Disability Access Report

**Residential Flat Building**

53-55 Donnison Street  
WEST GOSFORD NSW

For: SNZ Holdings +  
Australian Luxury Living  
Ref: LP\_20128

Figure 3 | Adaptable unit Layout - Typical

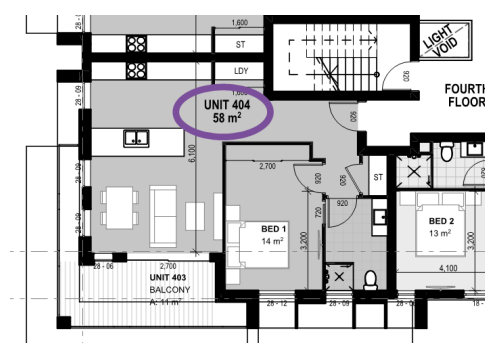
The entry doorway to the adaptable unit offers areas conducive to an accessible entrance and a leaf size of 920mm is nominated.

Bathroom offers a visitable toilet arrangement.

Doorways have a nominated leaf size of 920mm and adequate circulation areas are provided.

Doorways are generally provided with adequate circulation areas

Bathroom offers dimensions conducive to adaption

Kitchen offers circulation areas as described above.

The living area within the adaptable units is an open-plan area which meets the circulation requirements of AS4299.

Entrances to adaptable housing units are to comply with AS4299 Clauses 4.3.1 and 4.3.2. AS4299 which require that the entry doors comply with AS1428.2 **at time of construction**. The minimum clear opening width of the doorway is to be 850mm and allow for wheelchair maneuverability (provide minimum 1550mm long area in front of the doorway). Entrances to the adaptable housing units to be weatherproofed.

Each adaptable housing unit is required to have a toilet on the entry floor that is a visitable toilet within the meaning of AS4299 **at time of construction**. The toilet is to be installed in compliance with AS1428 (correct set-out distance from fixed walls) and have the capacity to accommodate a grabrail that complies with Figure 4.5 of AS4299. Slip resistant floors are also required.
